Bid Addendum Two

Project: **Tulip New Utilities Building**
Project No. Tulalip Tribes Project No. 2021-003

Date of Issuance: April 18, 2024

ELECTRICAL FIRST FLOOR LIGHTING PLAN

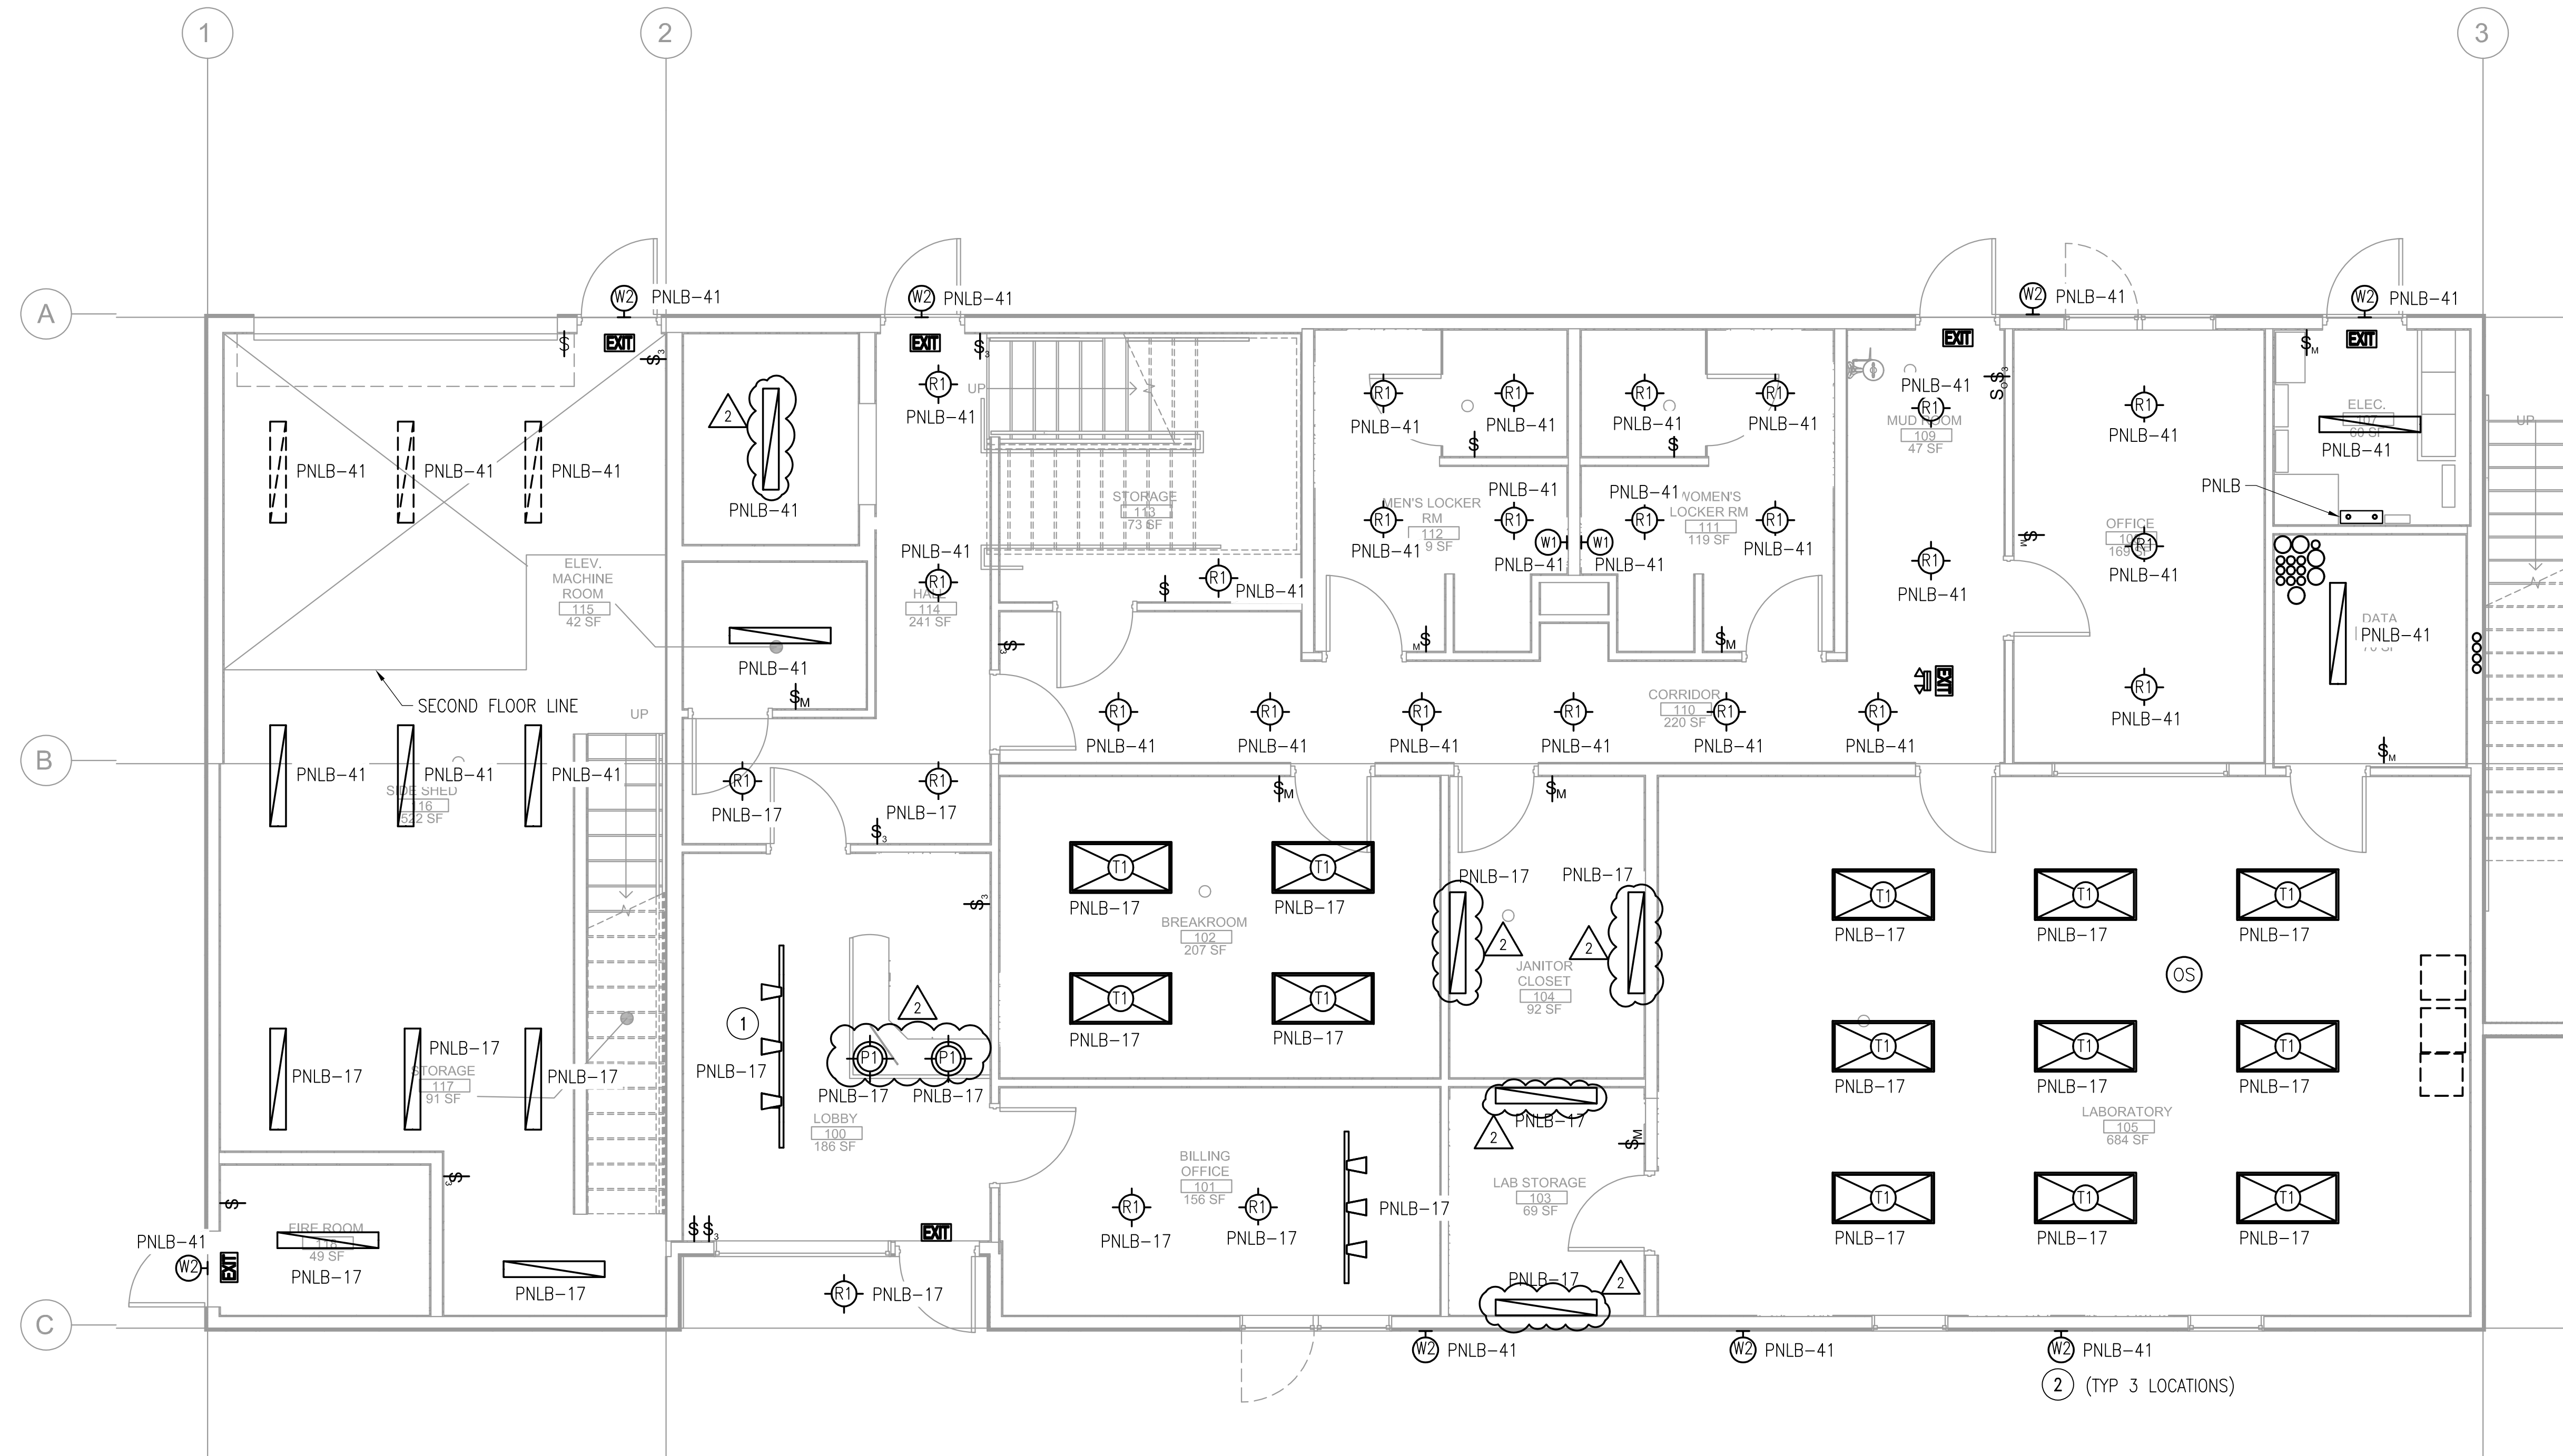
4. A21-188_New Utilities Building BID ADDENDUM 2 ELEC SHEETS.pdf
 - E1.0 – revised Legend for light fixtures
 - E4.0 – revised fixtures at elevator shaft, lobby, Janitor's Closet and Storage, revised lighting fixture schedule

SECOND FLOOR LIGHTING PLAN 1
SCALE: 1/4" = 1'-0" E4.1

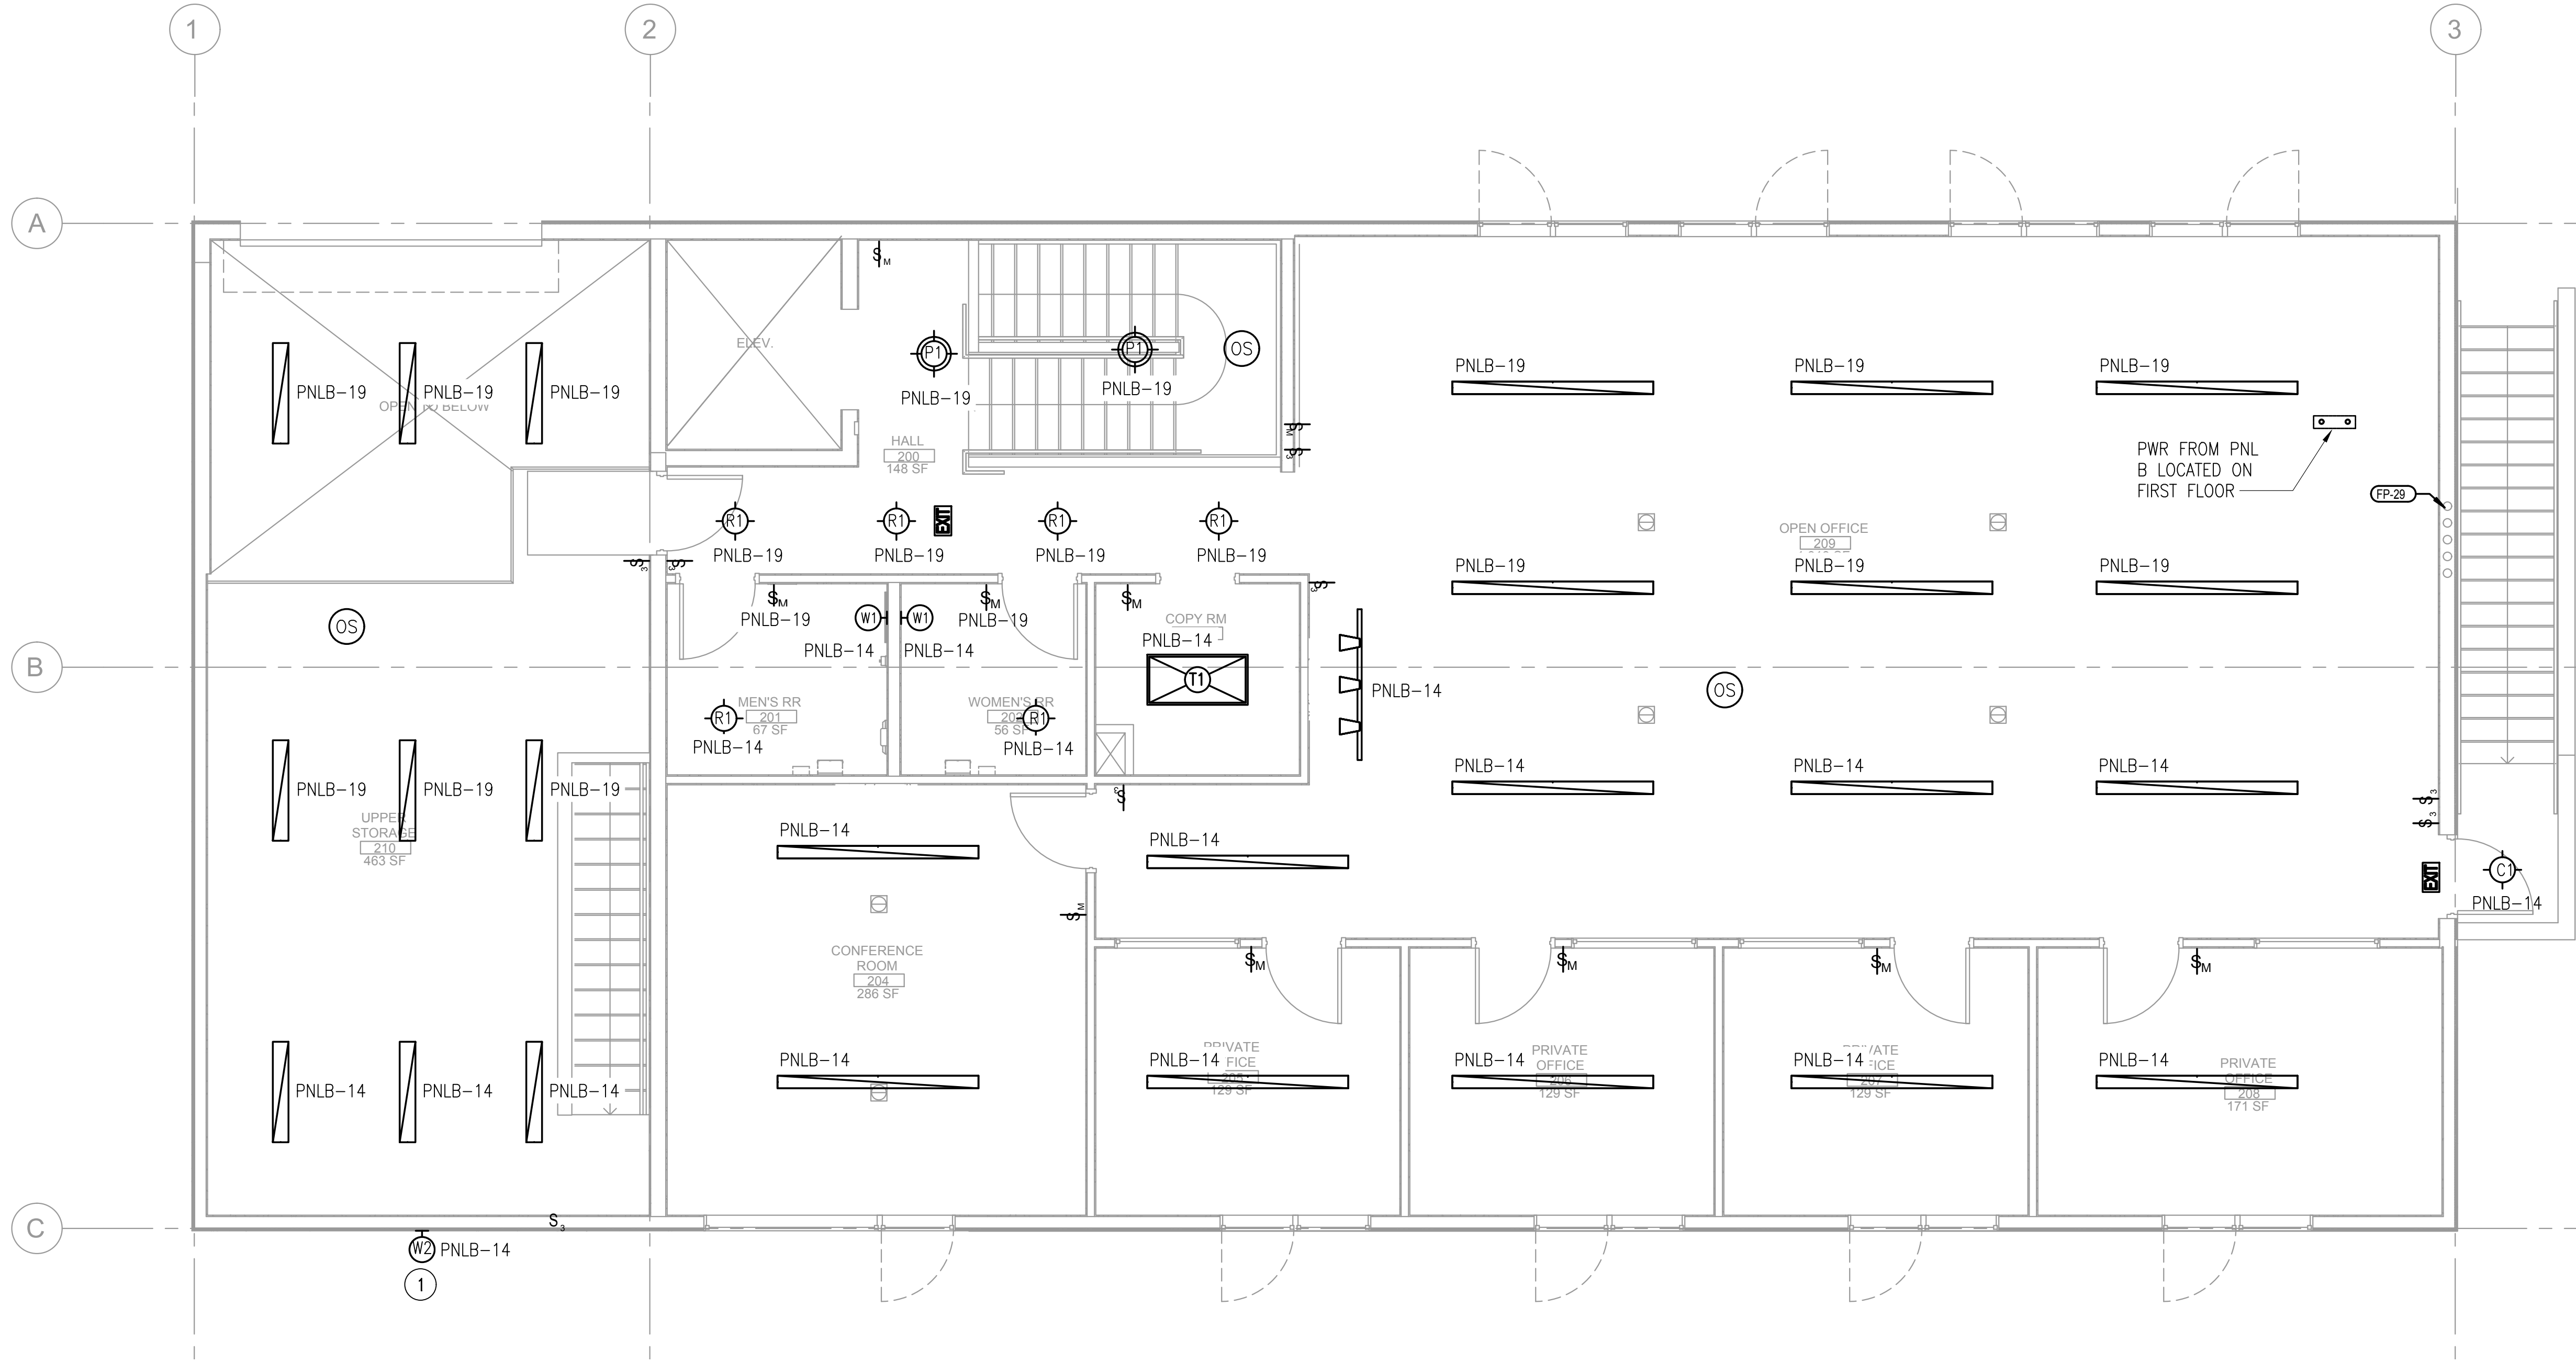
- E4.1 – revised lighting fixture schedule.
5. Bid Period RFIs 1 through 13 compiled.

12 EAST ELEVATION - EXTERIOR STAIR

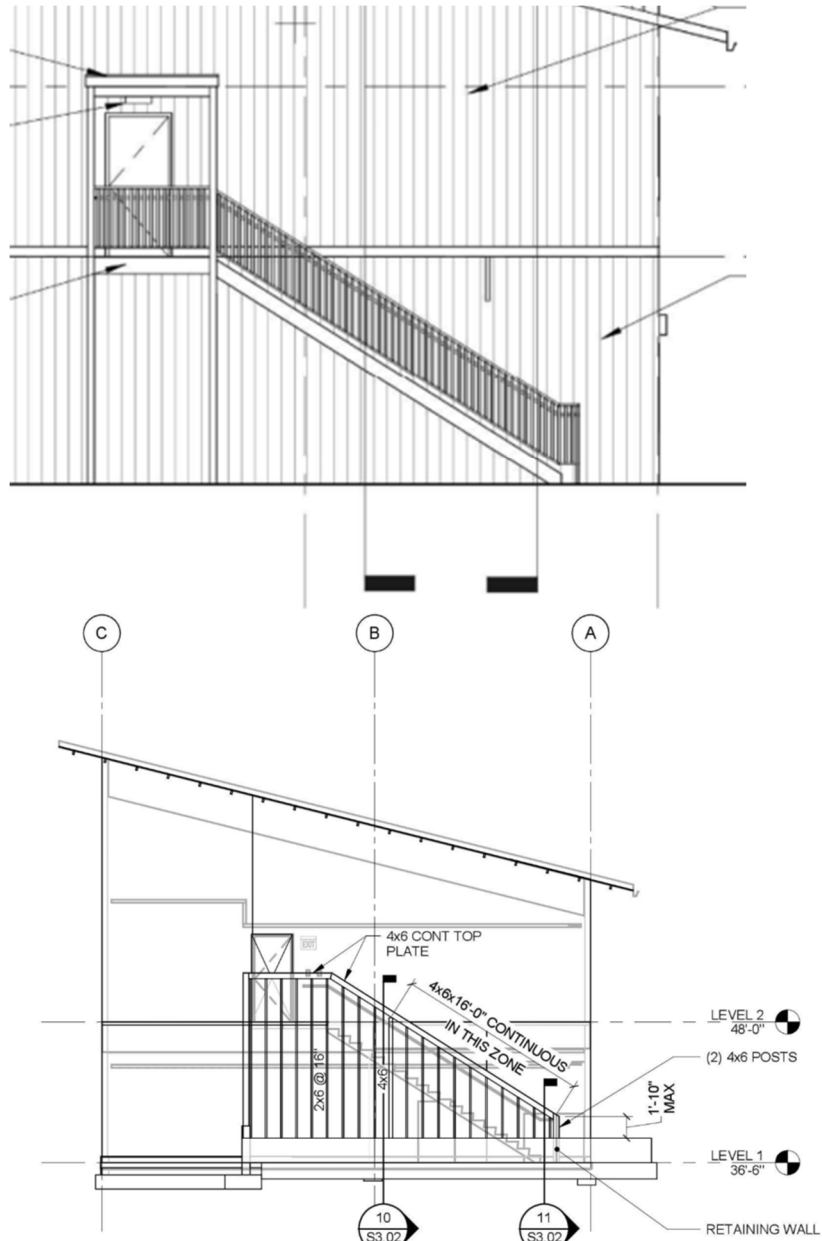
Architectural Set Sheet A4.00 Detail 3 Shows Steel stairs with metal picket handrail. Structural sheet S3.02 Detail 12 shows the exterior wall with Framed exterior wall with 4x6 post. Please Advise If wood framed wall is needed.
